Project	IEEE 802.16 Broadband Wireless Access Working Group < http://ieee802.org/16 >	
Title	MBS AES-CTR Enhancement	
Date Submitted	2005-01-10	
Source(s)	Junhyuk Song, Jicheol Lee, Yong Chang, Jungje Son Samsung Electronics	Voice: +82-31-279-3639 junhyuk.song@samsung.com
Re:	Re: IEEE P802.16e/D5a	
Abstract	Proposal to reduce existing 4 bytes nonce in AES-CTR MPDU to 1 byte by using Frame number	
Purpose	Discuss and Adopt as the baseline text	
Notice	This document has been prepared to assist IEEE 802.16. It is offered as a basis for discussion and is not binding on the contributing individual(s) or organization(s). The material in this document is subject to change in form and content after further study. The contributor(s) reserve(s) the right to add, amend or withdraw material contained herein.	
Release	The contributor grants a free, irrevocable license to the IEEE to incorporate material contained in this contribution, and any modifications thereof, in the creation of an IEEE Standards publication; to copyright in the IEEE's name any IEEE Standards publication even though it may include portions of this contribution; and at the IEEE's sole discretion to permit others to reproduc

Figure-xxx- MBS MAC PDU Ciphertext Payload Format

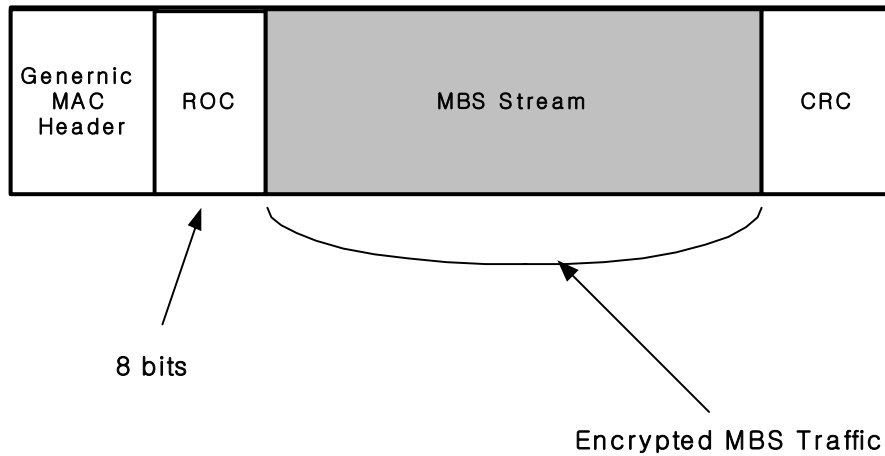
The PDU payload for AES-CTR encryption shall be appended with a ~~832~~bits rollover counter ~~nonce~~(ROC) ~~that indicate MSB of 32bits nonce randomly generated by base station. ROC is the— number of times 24bits frame number repeated and it shall not be encrypted. It The nonce shall be transmitted in little endian order.—The nonce shall not be encrypted.~~

The processing yields a payload that is ~~832~~bits longer than the plaintext payload.
